SR 25 CO/West Bay Street From I-516 to the Bay Street Viaduct

NHS00-0002-00(923), P.I. No. 0002923
Chatham County, Georgia

Value Engineering Study Report

September 2009

ALT. NO. G-1
Sht 5 of 15

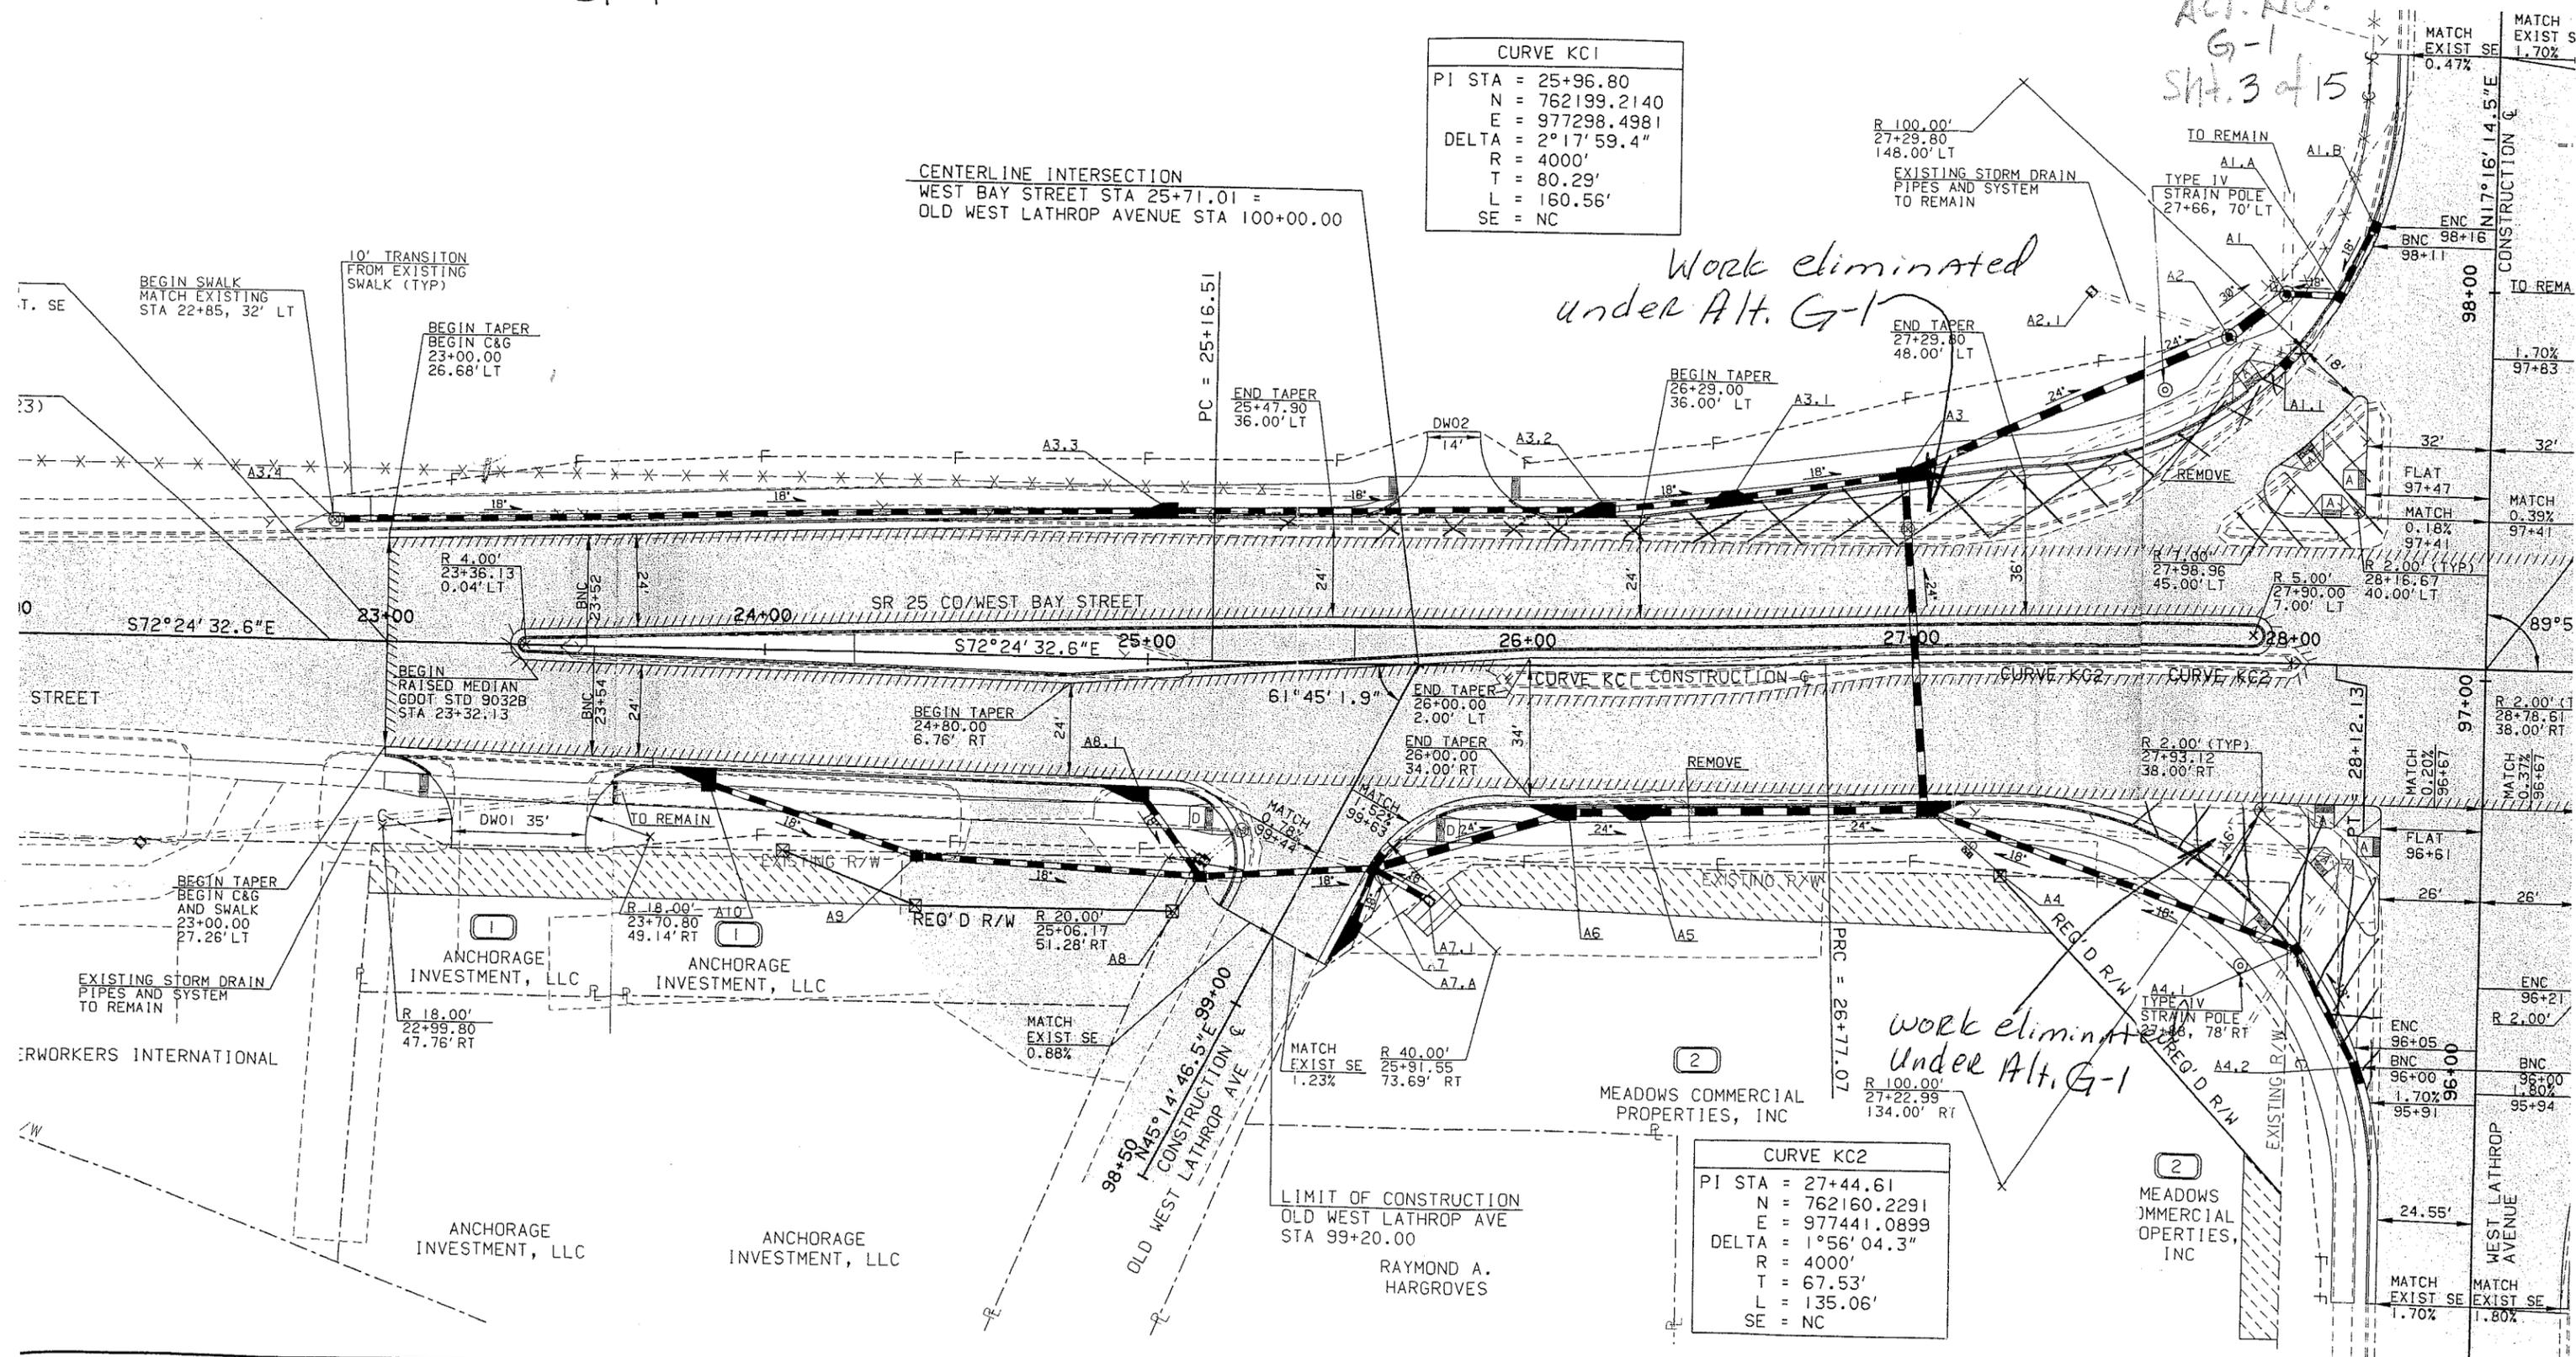
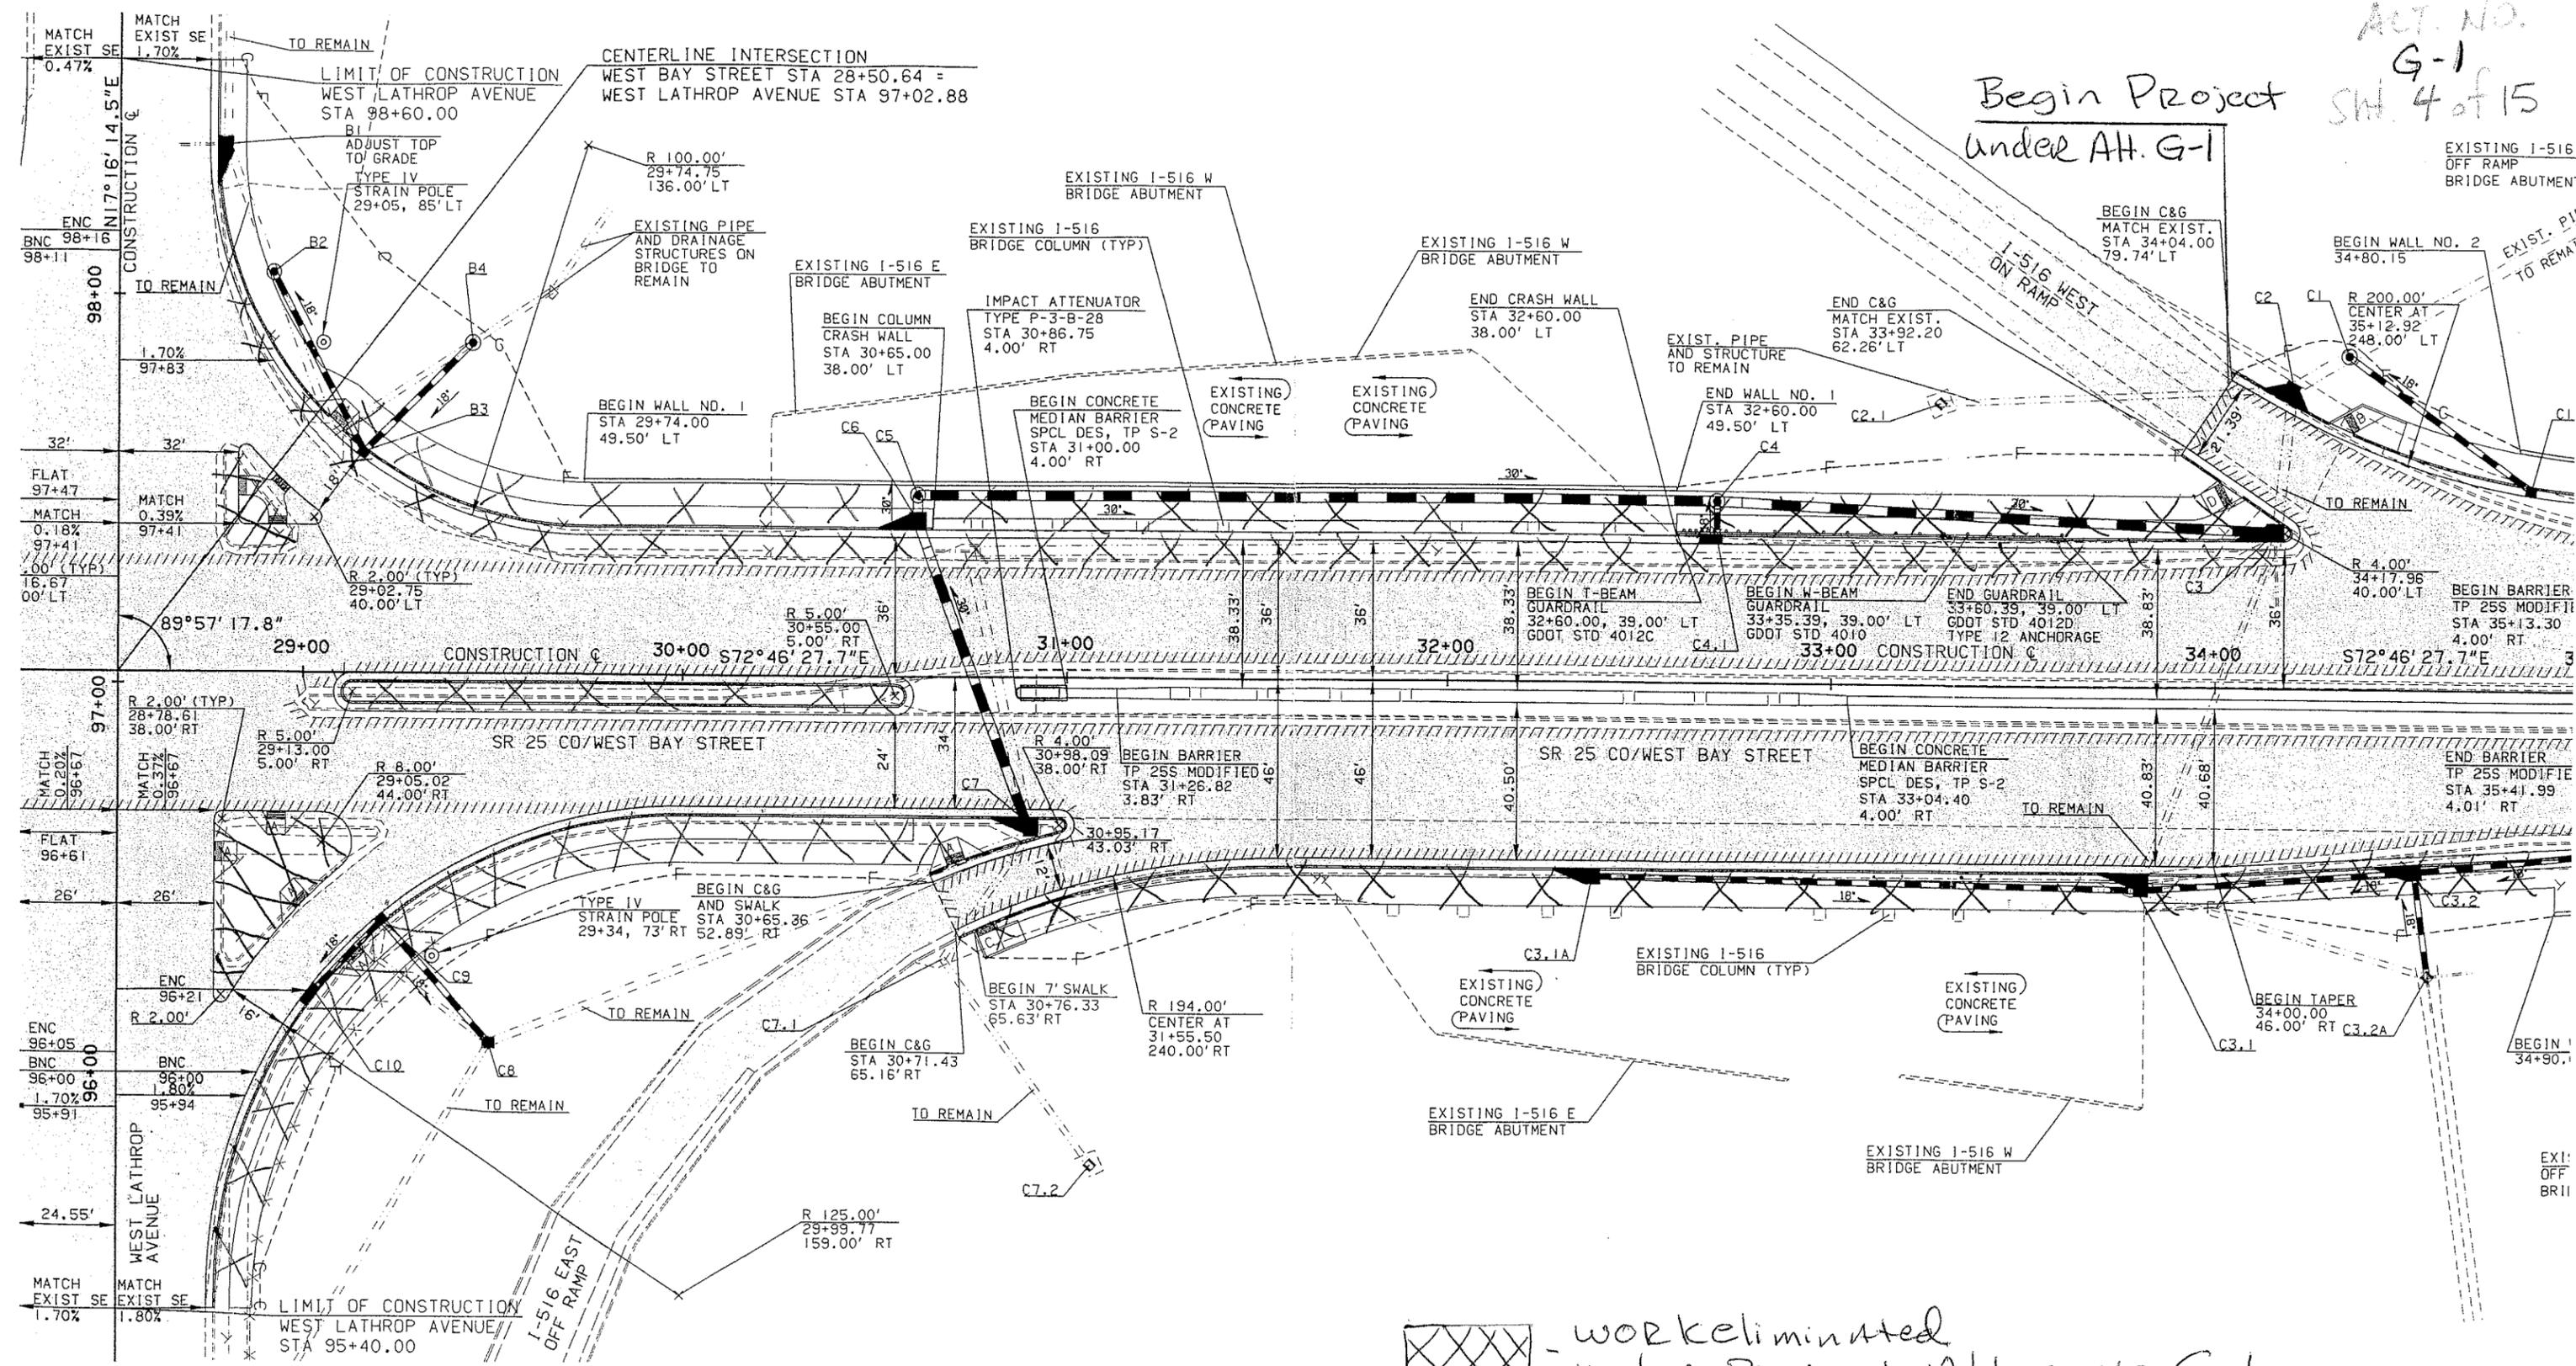
The necessity for the U-turns at this location is questionable. The limited number of vehicles desiring to go west on SR 25 CO/West Bay Street from Old West Lathrop Avenue could go to Augusta Avenue, turn left onto Augusta Avenue, left onto northbound West Lathrop Avenue and left onto SR 25 CO/West Bay Street.

It is also questionable whether the sidewalk on the north side of SR 25 CO/West Bay Street is needed. In order to use this sidewalk, a person would have to cross the free flowing entry ramp to I-516 westbound, which is not safe. In addition, the origin and destination of potential users of this sidewalk is not readily apparent.

Providing a protected right turn from eastbound SR 25 CO/West Bay Street to southbound West Lathrop Avenue is questionable given the maximum hourly volume of 23 vehicles.

Work eliminated under Alt. G-1
